**BEFORE
THE OHIO POWER SITING BOARD**

In the Matter of the Application of)	
Kingwood Solar I LLC for a Certificate)	Case No. 21-0117-EL-BGN
of Environmental Compatibility and)	
Public Need)

**KINGWOOD SOLAR'S JUNE 1, 2021 RESPONSES
TO STAFF'S MAY 17 AND MAY 20 DATA REQUESTS**

Figure 08-11
Land Use within One Mile
Sheet 6 of 29
Kingwood Solar
Greene County, Ohio

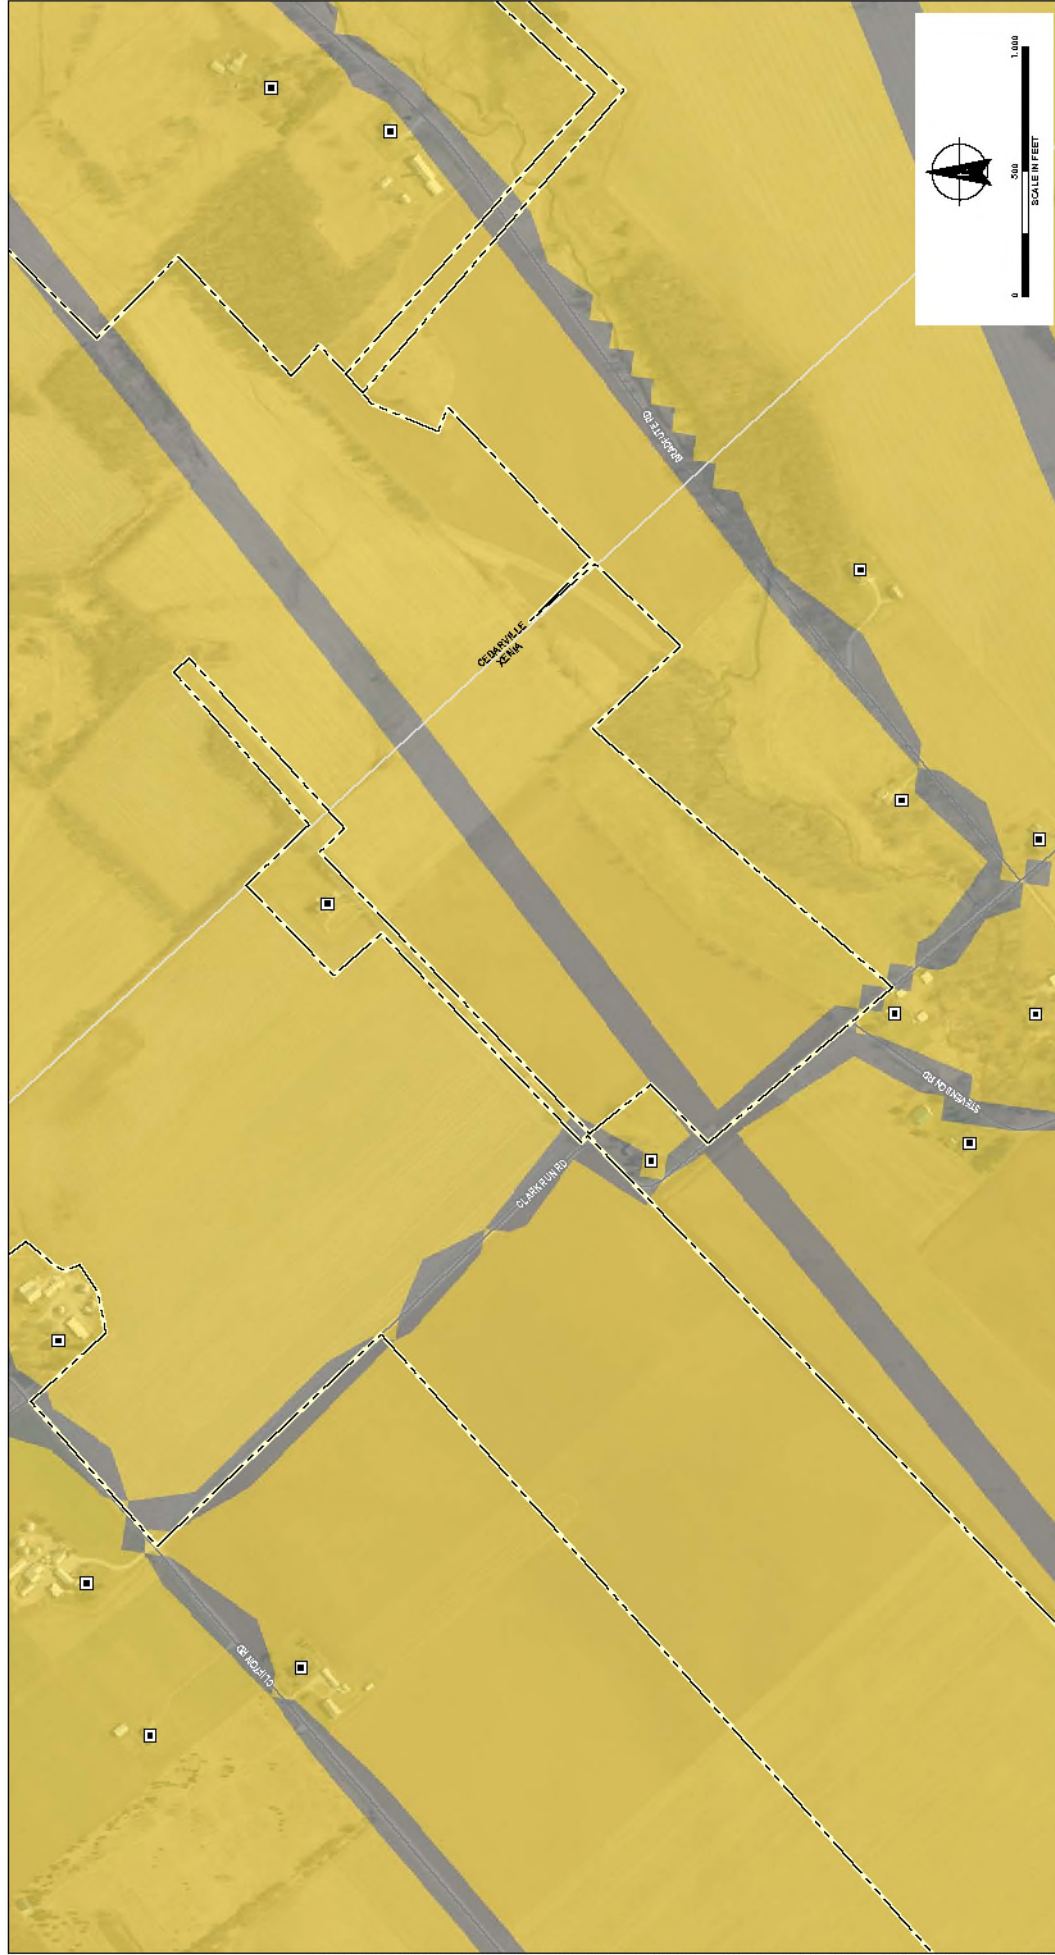
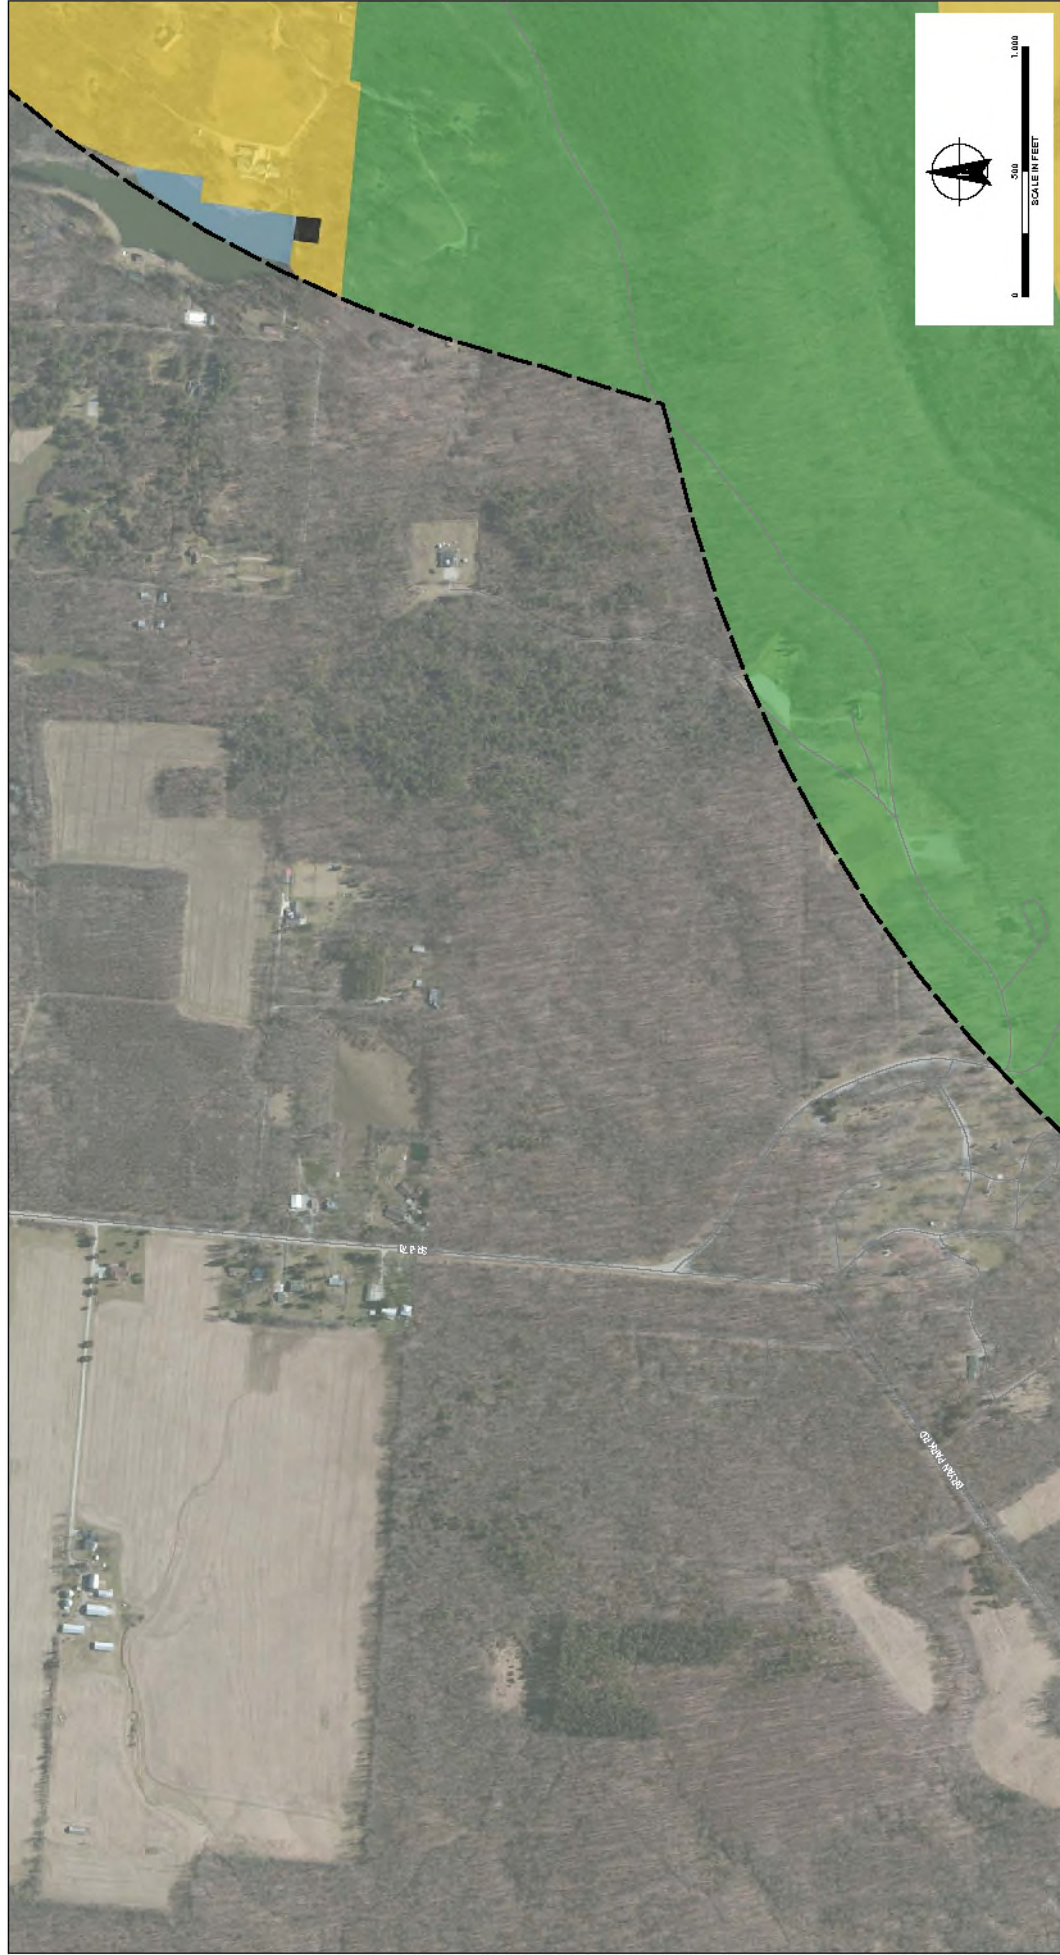
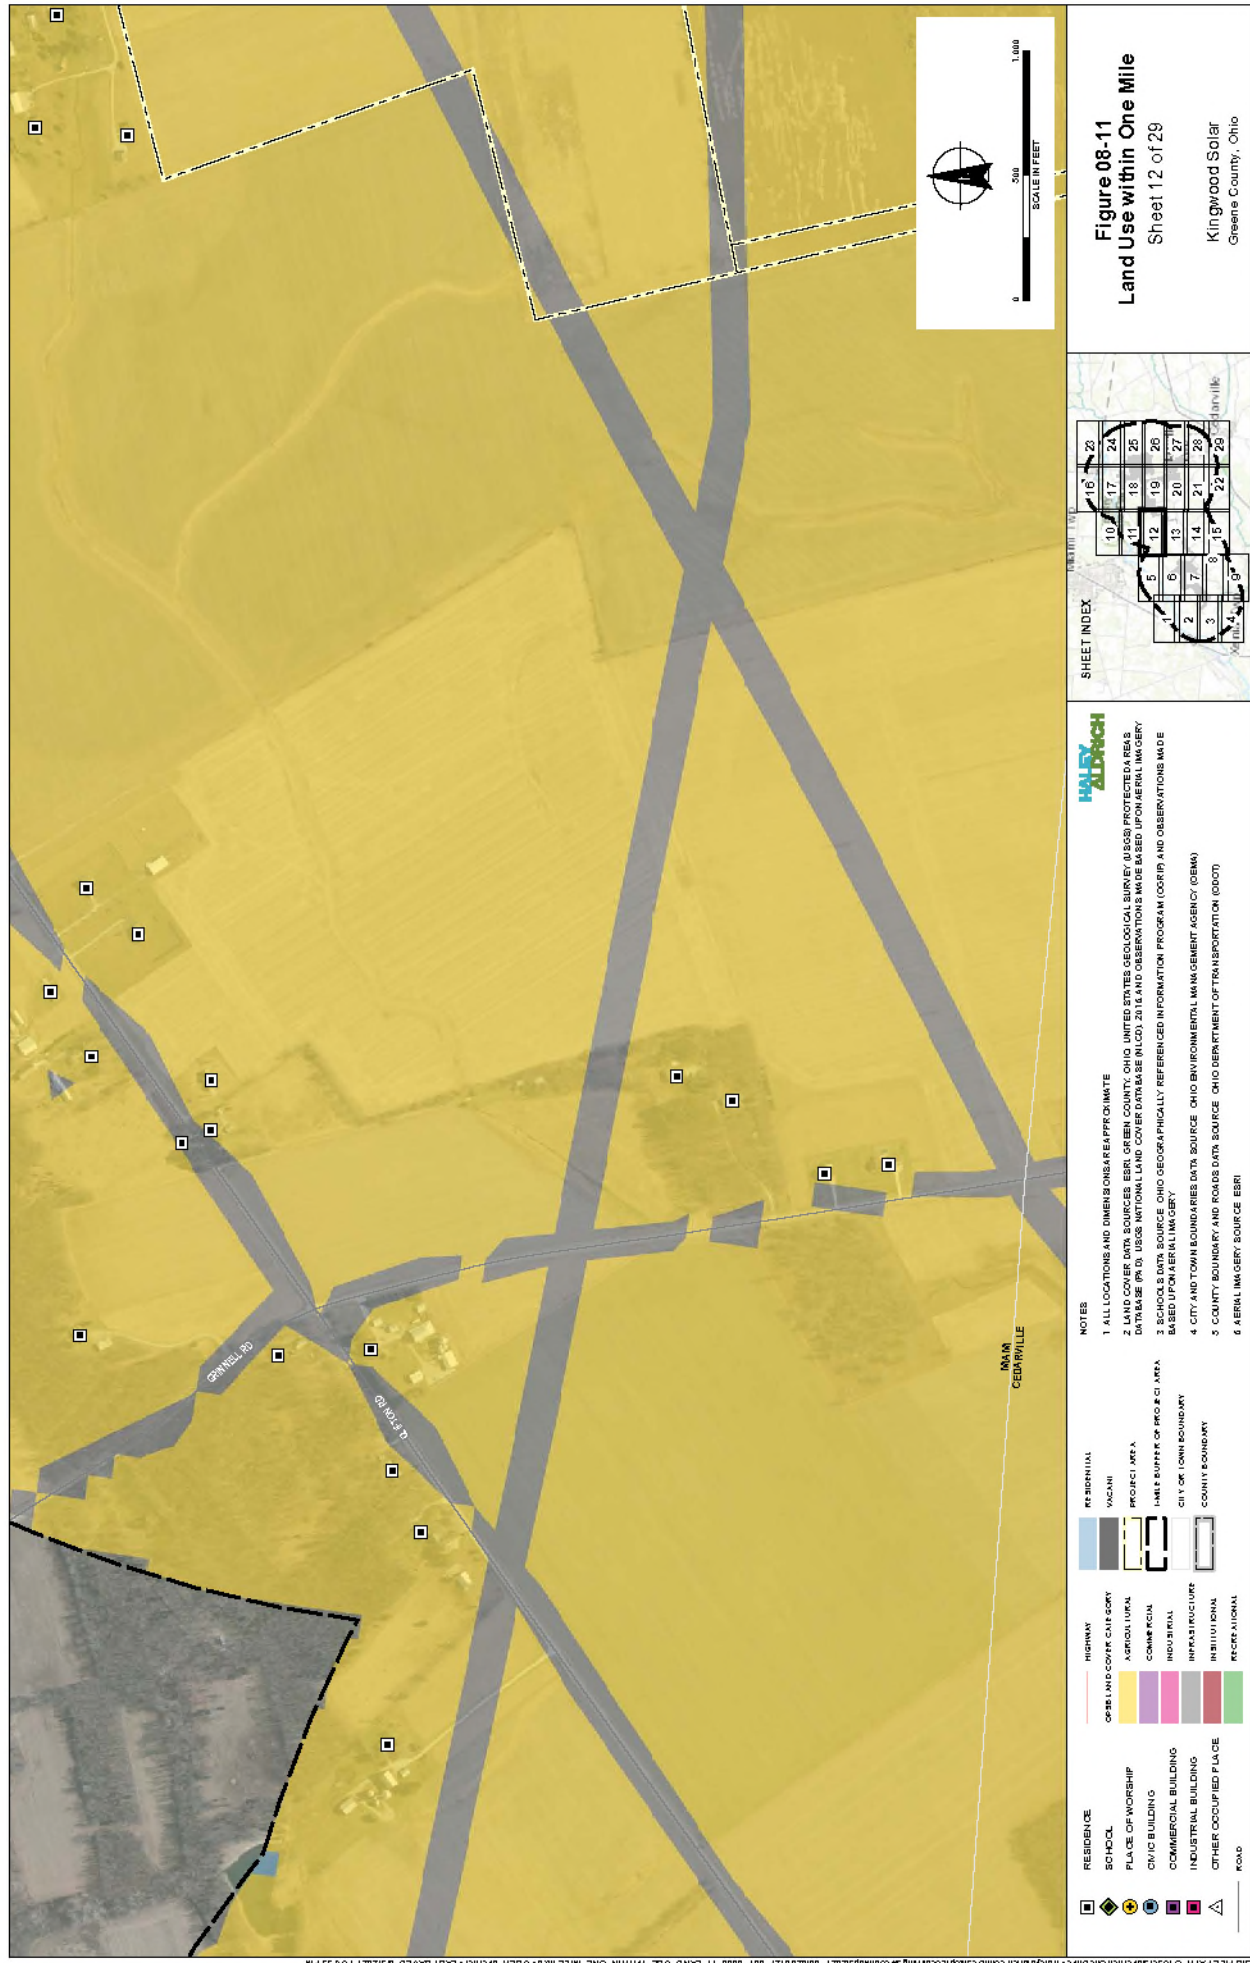
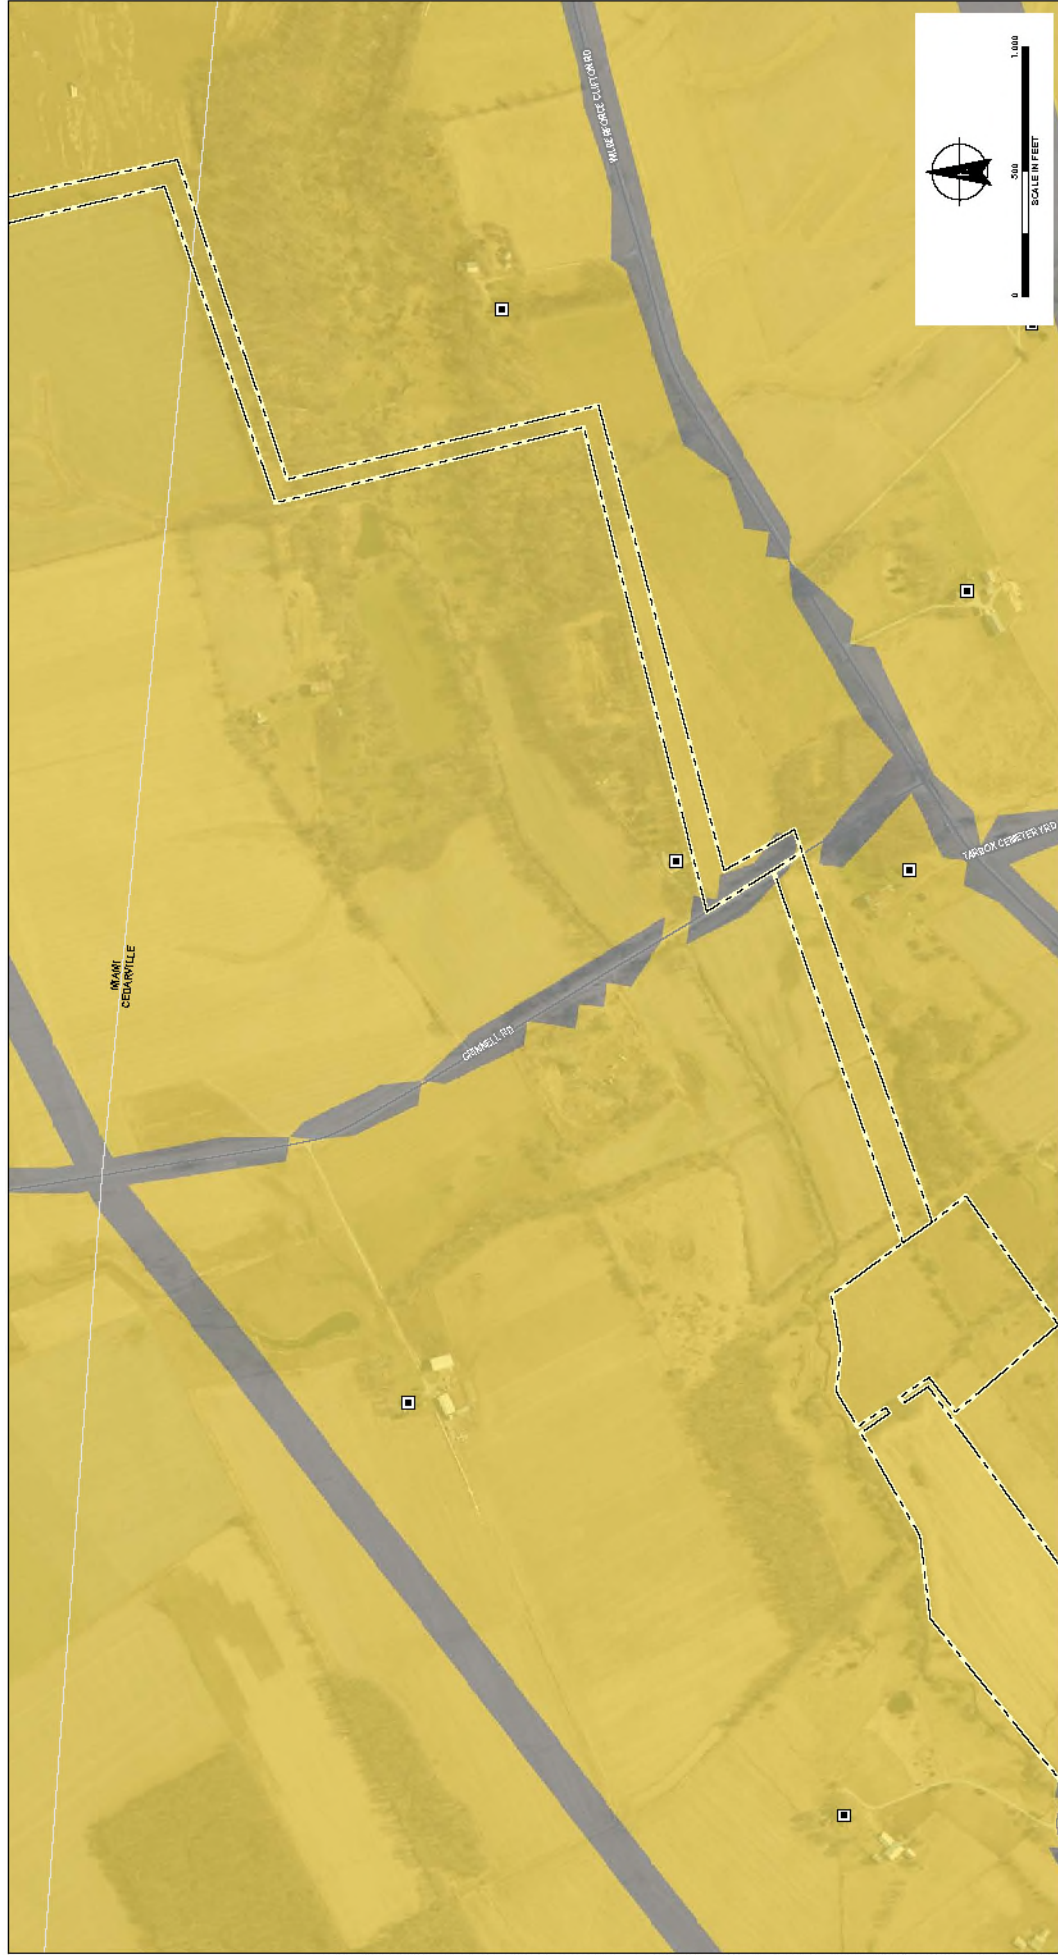
1. *Figure 8-11 currently only delineates schools and residences. Amend Figure 8-11 to include the following structures depicted as points on the map, as per 4906-4-08(C)(1)(a): "...commercial centers or buildings, industrial buildings and installations,...hospitals, churches, civic buildings, and other occupied places".*

A revised version of Figure 08-11 is attached that provides points on the maps for the requested features.
